D/DRC Case

1300 Geiger Avenue
Cottontown/Bellevue Architectural Conservation District
TMS: 09109-07-01

DESIGN/DEVELOPMENT REVIEW COMMISSION
DESIGN REVIEW DISTRICT
HISTORIC AGENDA
EVALUATION SHEET
Case # 6

NATURE OF REQUEST: Request Certificate of Design Approval for exterior change

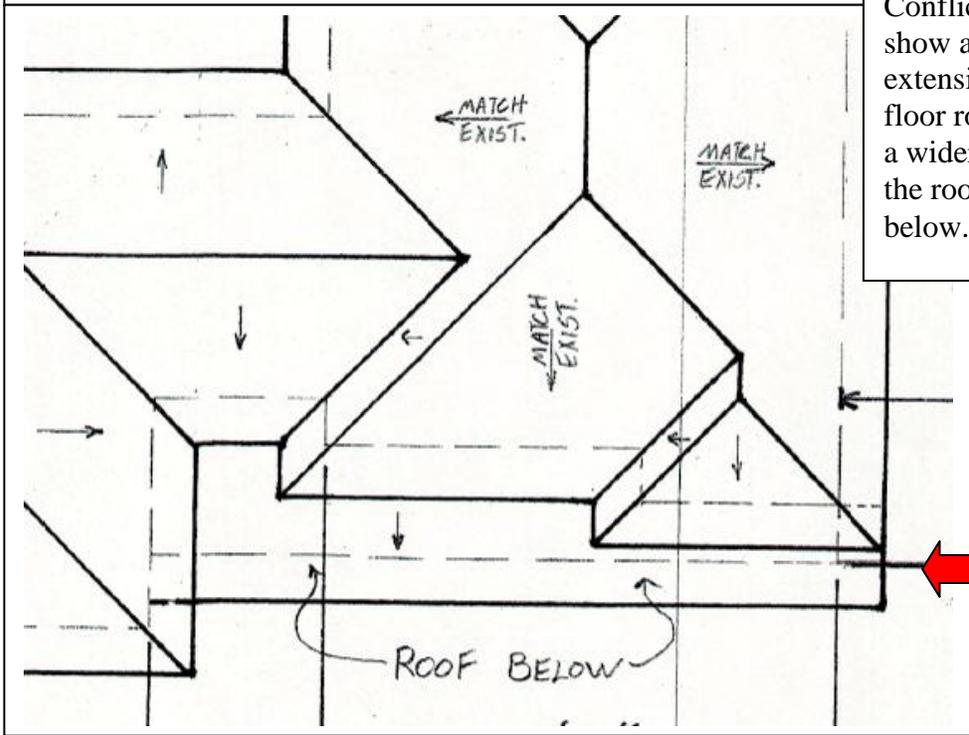
The roof pitch as built is compatible, but this is actually a shed roof with a partial gable detail at the end, which is not visually compatible with the surrounding buildings. A shed roof is found in the façade of the house to the left of 1300 Geiger, but it is part of a pedimented gable and does not extend past a wall plane. A shed roof that ends with a gable

end detail projecting from the rear wall is not visually compatible with surrounding buildings.

Original Plans from applicant and part of original evaluation:

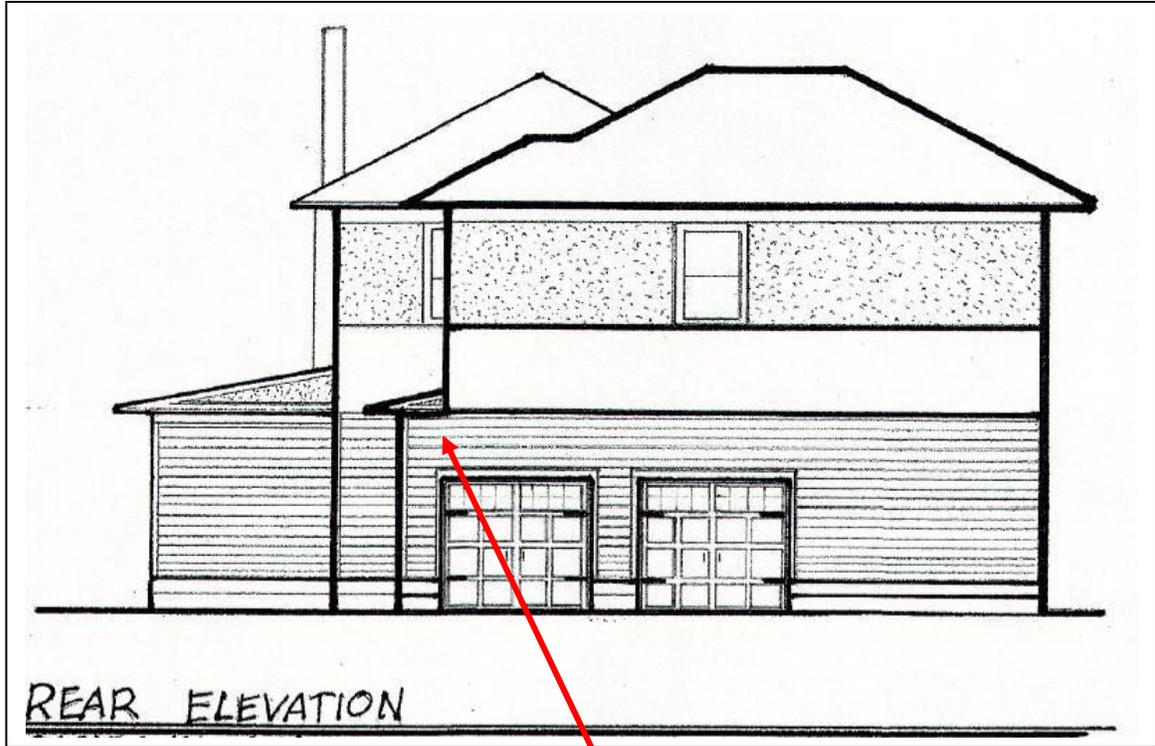
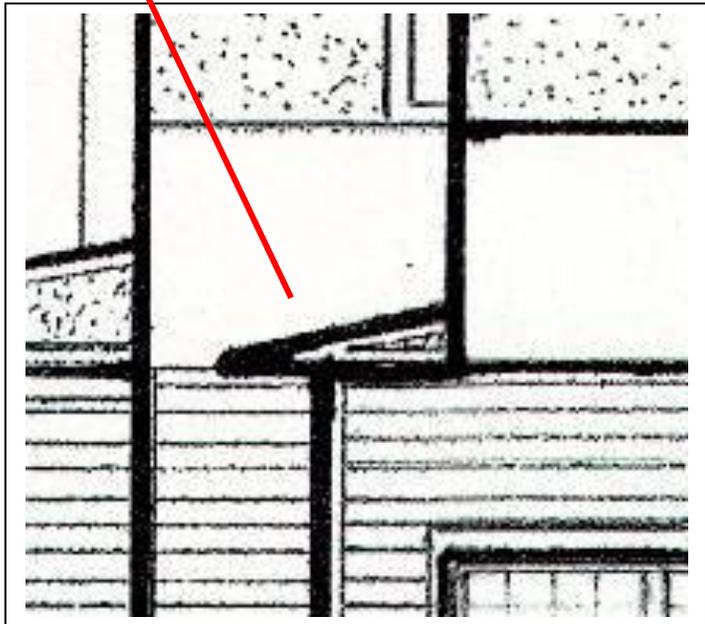
Conflicting drawings show a shallow extension of the first floor roof above and a wider extension in the roof plan drawing below.

Detail of design as originally submitted for the end of the first floor roof.

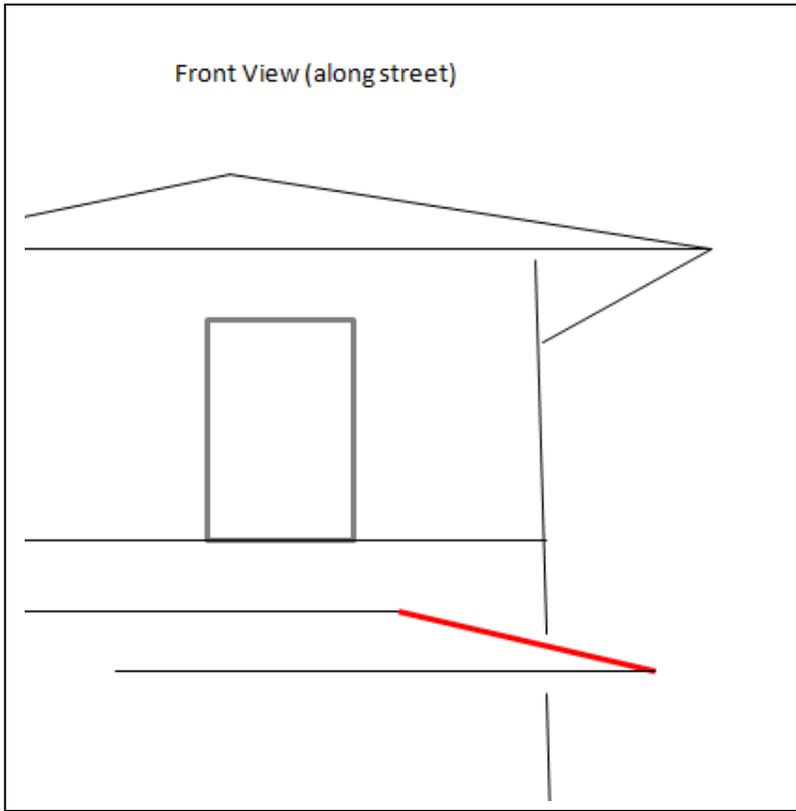
Gables and gable ends in a house and garage immediately to the rear of 1300 Geiger Ave. that the contractor pointed out as nearby examples.

Staff's understanding of what the contractor was creating is shown above. He was trying to create a feature that reads as a remnant of a gable that was later removed. The part projecting from the building off of the shed roof would have been a gable end if a gable (red line) had continued across the rear wall.

Staff's recommendation of a half hip at the edge to complete the first floor roof in a way that is visually compatible with the historic house.
